# PARTS & SERVICE NEWS

REF NO.	AA02263
DATE	December 04, 2002

- SUBJECT:** LIGHT SENSITIVE DIODES IN STATEX AND AC ELECTRIC DRIVE SYSTEMS
- PURPOSE:** To inform the field of potential problems with battery boost module diodes on alternator exciter panels.
- APPLICATION:** Komatsu Electric Drive Dump Trucks:  
 930E-2: A30012, A30098, A30100, A30121 & Up;  
 930E: 32604-32816, A30019, A30026-A30120;  
 \*830E: 31320-32825, A30544 & Up;  
 \*730E: 32530-32845, A30079 & Up;  
 \*630E (190 ton): 31678-32848, A31431 & Up;  
 \*630E (170 ton): 31670-32866, A31435 & Up;  
 \*685E: 31402 & Up;  
 \*510E: 31222-32259, 31682-32865;  
 \*445E: 32210-32972, 31202-31736, A511001-A511037;  
 \* *equipped with STATEX I, II, OR III SYSTEMS*

FIGURE 1. BLACK DIODES

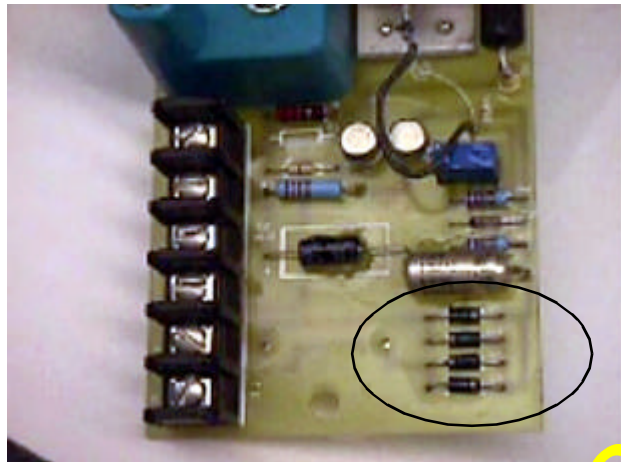
Figure 1 shows normal operating black diodes. If these diodes are found, no action is necessary. Figure 2 shows the gray-colored, light sensitive diodes. Action is required if these diodes are found. Figure 3 shows gray diodes after a countermeasure action has been performed.

FIGURE 2. GRAY-COLORED,  
LIGHT SENSITIVE DIODES

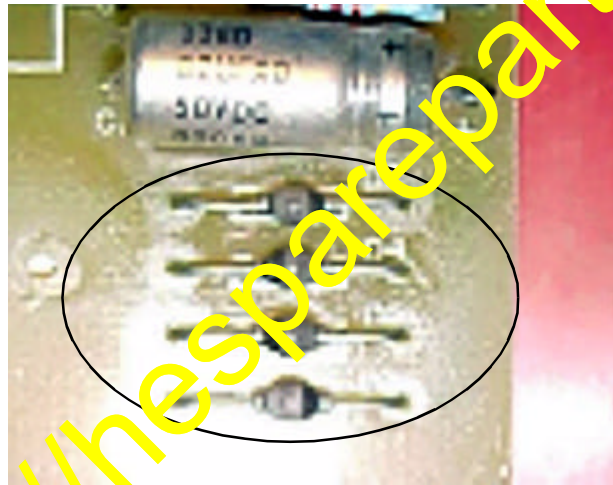
Inspect the circuit card on the VE0687 battery boost module on the PB8838 alternator exciter panel. Observe the color of the diodes (D2, D3, D4 & D5). If the diodes are gray in color (Figure 2), one of the following actions must be performed on the diodes:

- paint with black or other dark colored paint
- color with a permanent, black felt tip marker
- cover with black electrical tape

Performing one of these actions on the diodes will prevent light from affecting diode operation and subsequent malfunctions.
